NRL/MR/7441--94-7097

## Digital Mapping, Charting, and Geodesy Analysis Program Technical Review: Digital Nautical Chart Product 1

December 9, 1994

Fig. 10 — DNC data for Ocracoke Light

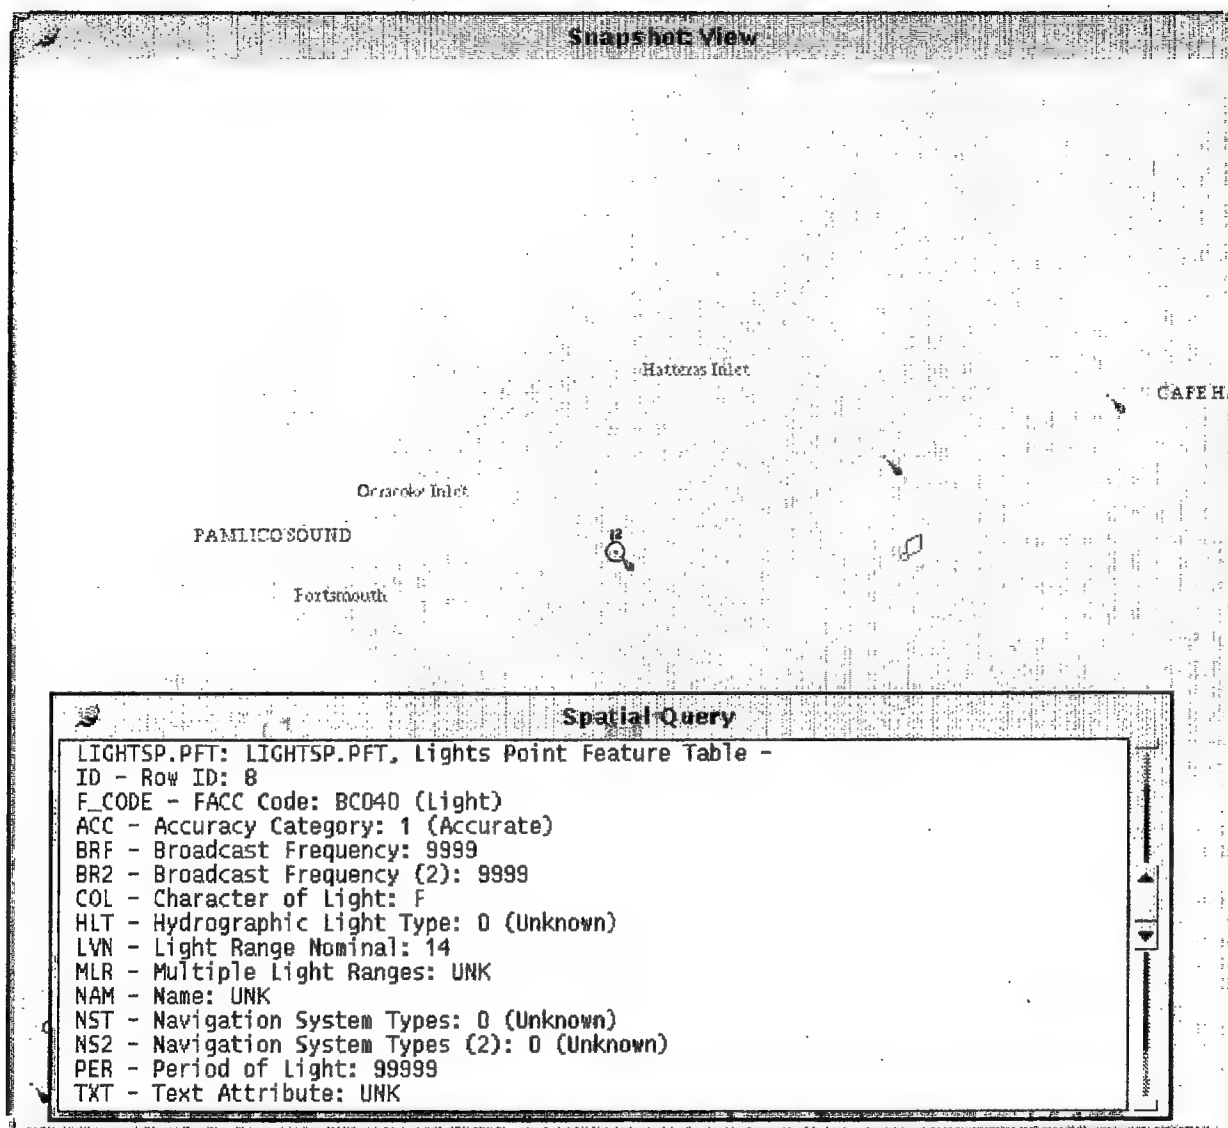
76. The attributes for Aids to Navigation should be expanded so that at a minimum they contain all of the information found in the Light List and List of Lights. This would involve adding only a few more attributes to the DNC, but the time saved for the user would be enormous (Fig. 9). Additional attributes would describe the fixed structures upon which aids are mounted, any emergency lights, any seasonal remarks (some buoys are replaced or removed during winter), any private aid identification, and the year established, moved or rebuilt. This would significantly reduce the excessive entries of "Unknown" as currently done for attribute values (Fig. 10), thus making the DNC a more complete and informative database.
